Docket Number:	23-OPT-01
Project Title:	Fountain Wind Project
TN #:	251462
Document Title:	fwp_memo_lu_soc_alts_2023-0802
Description:	N/A
Filer:	Caitlin Barns
Organization:	Stantec Consulting Services, Inc.
Submitter Role:	Applicant Consultant
Submission Date:	8/2/2023 11:09:20 AM
Docketed Date:	8/2/2023

Re: Memorandum addressing sufficiency of responses for ALT-01, LU-002, LU-003, LU-006, LU-010, LU-012, LU2-01, LU2-02, LU2-04, LU2-05, MOR-029, MOR-030, SOC-001, SOC-004, SOC-006, SOC-007, SOC-008, SOC-013, SOC-021, SOC2-007, SOC2-008, SOC2-009, and SOC2-014

Off-Site Alternative

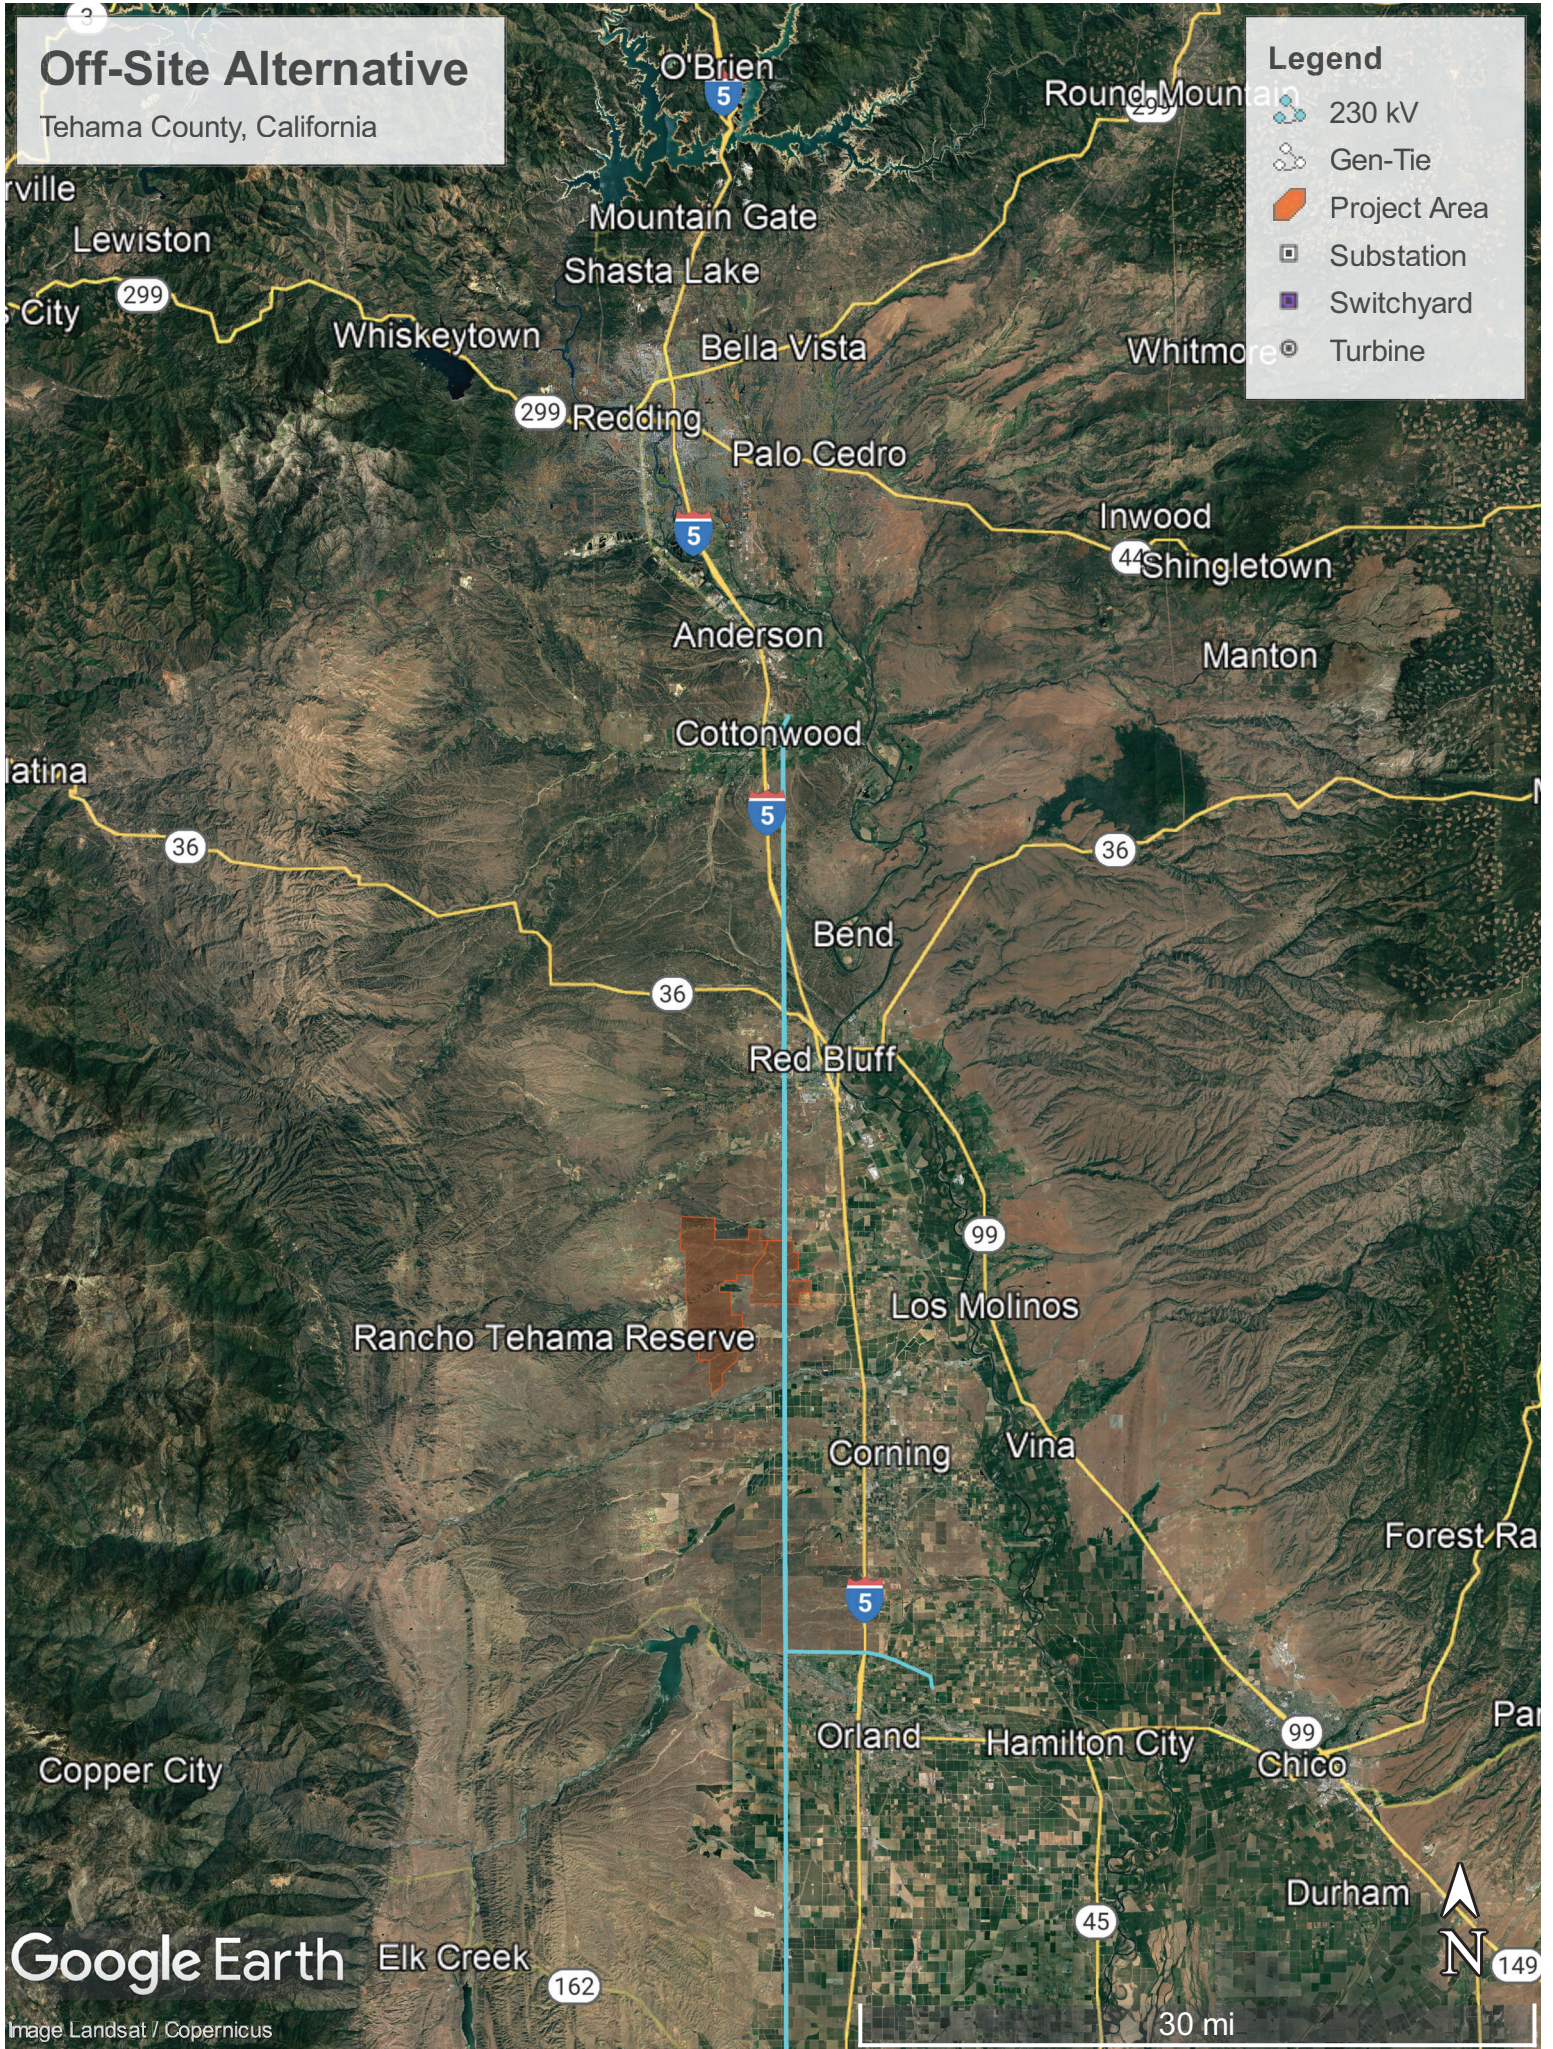
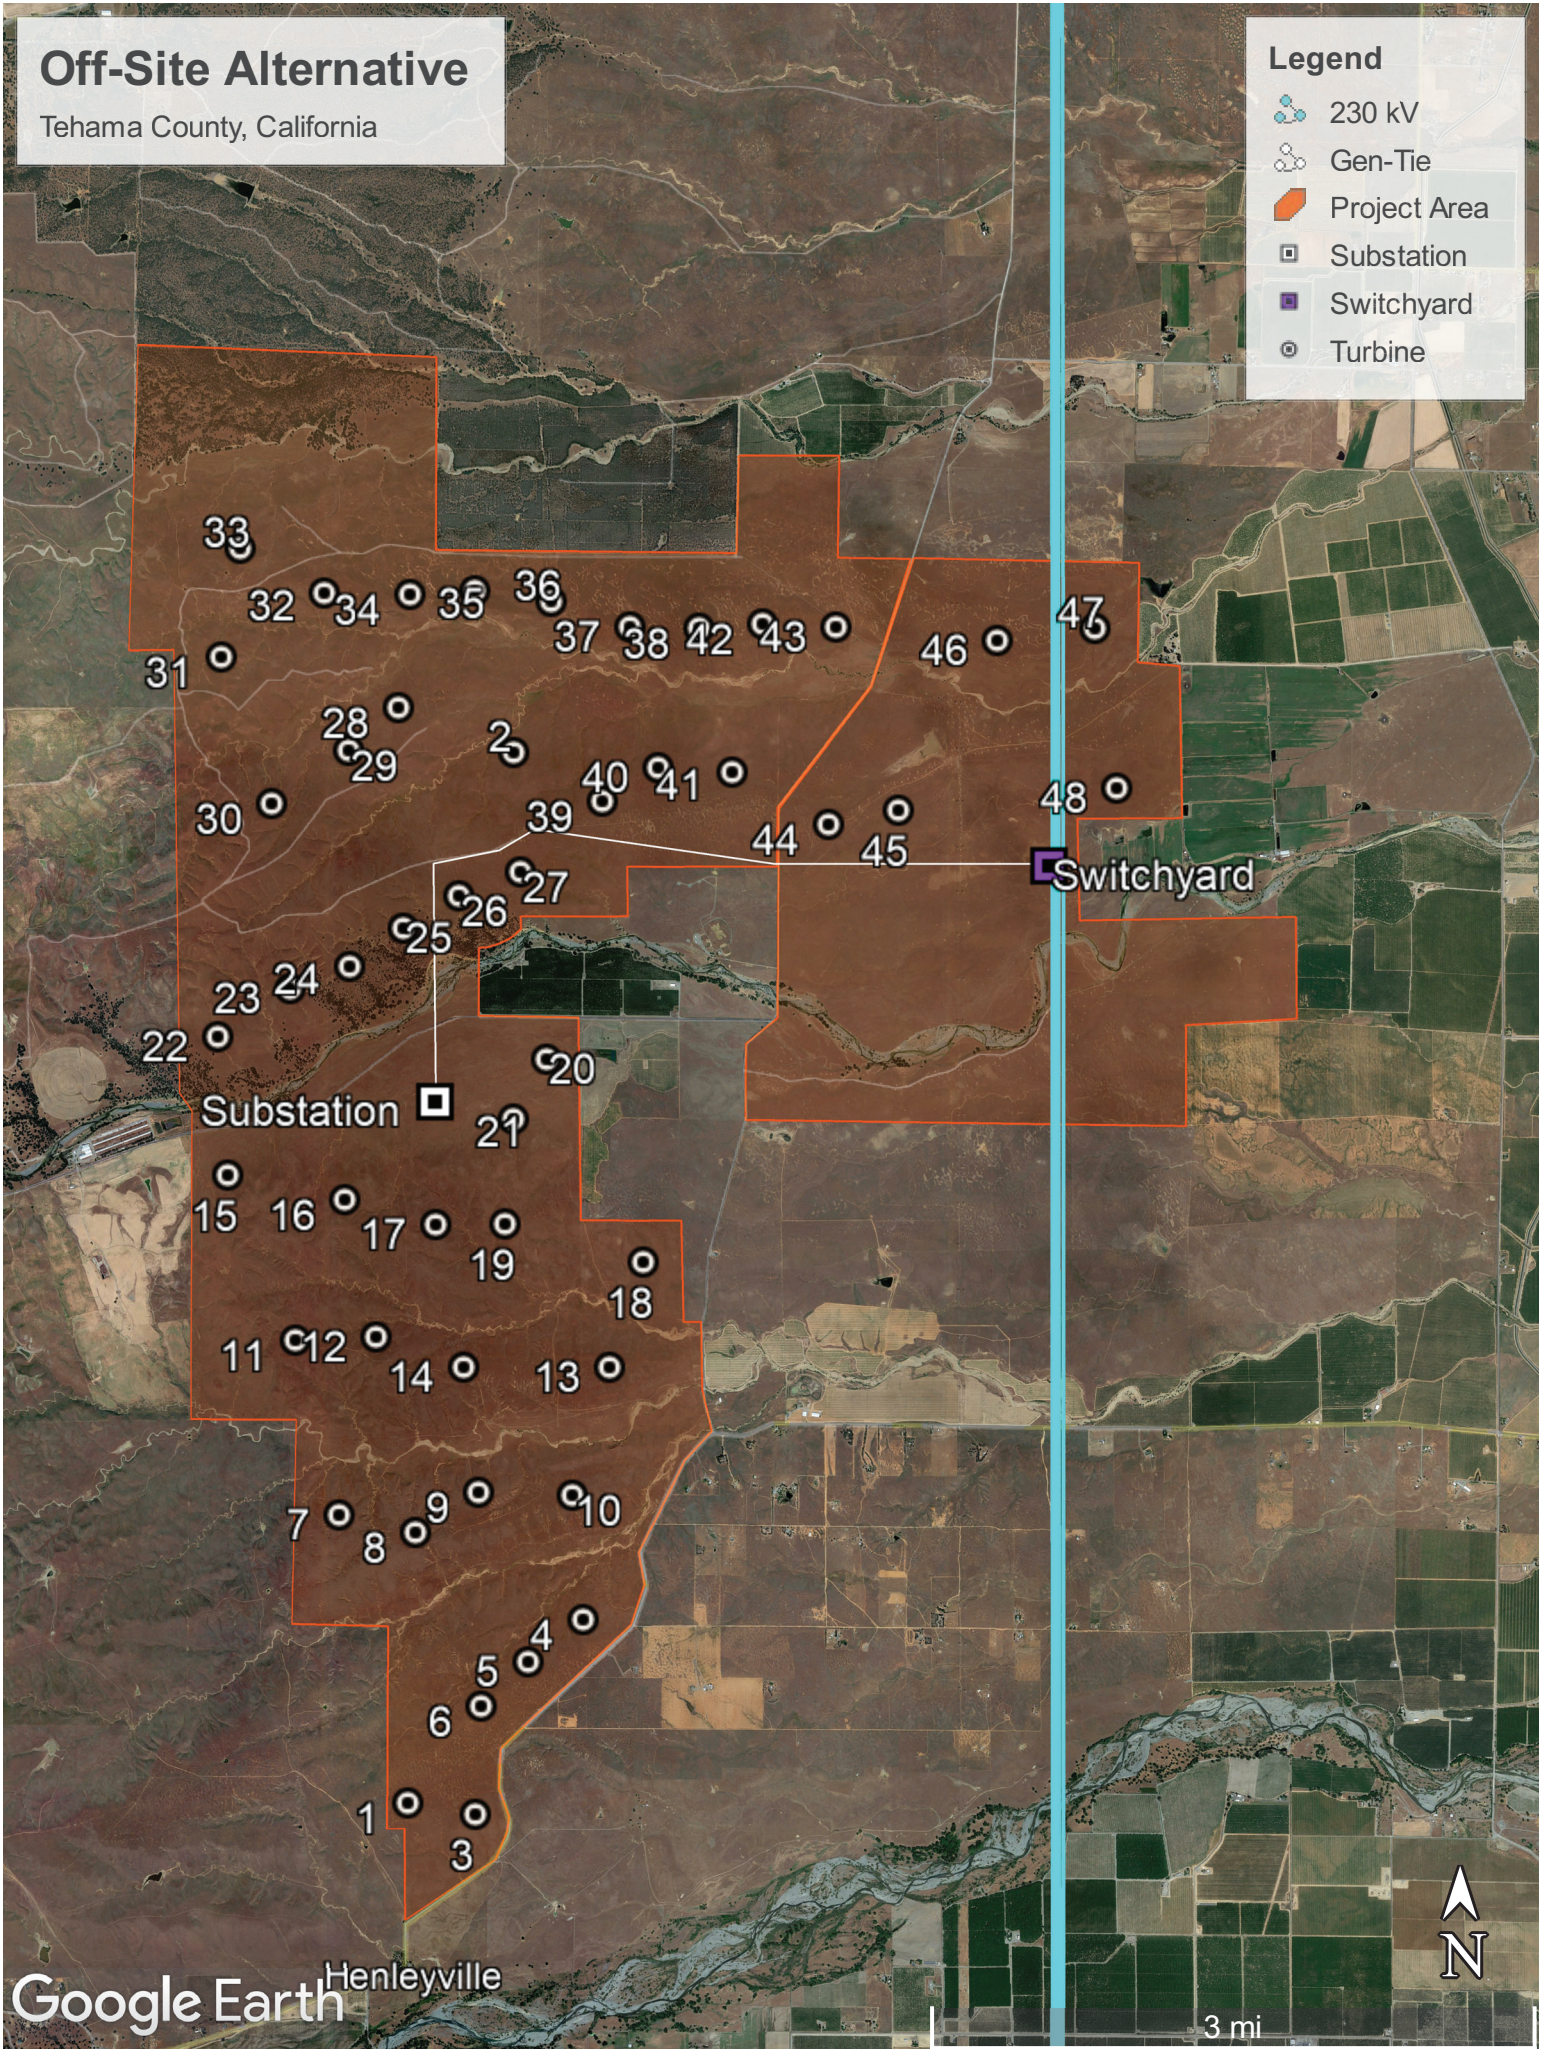
CEC Data Request: 1. Please provide a feasible alternative site for the development of a large wind energy system (outside of unincorporated Shasta County) that meets the basic project objectives, and include the following information:

- a. A map illustrating the alternative site location;
- b. Number of wind turbines and approximate size of the turbines that could be constructed;
- c. Details on project components including access roads, substation/ switching station, transmission line details (voltage, route, number of towers, etc.);
- d. How the site meets the project objectives; and
- e. Any other additional infrastructure and facilities that would be needed to support the development of a large wind energy system and its connection to the energy grid.

Alternative Site¹ – 13,125 acres of private land in Tehama County – 48 turbines, 205 MW; a map is attached as Exhibit 1; 4.25 mile gen-tie line; connecting to existing 230 kV PG&E transmission system via a tap of one of the four parallel lines listed below.

- Cottonwood to Cortina 230 kV
- Logan Creek to Cottonwood 230 kV
- Cottonwood to Vaca Dixon 230 kV
- Cottonwood to Glenn 230 kV

Transmission upgrades required, at a minimum, would include a new interconnection switchyard as well as other Network Upgrades as identified by the Grid Operator (CAISO) through an interconnection request and associated study work. A similar number of new access roads and ground disturbance would be required for this off-site alternative as the proposed project. A project at
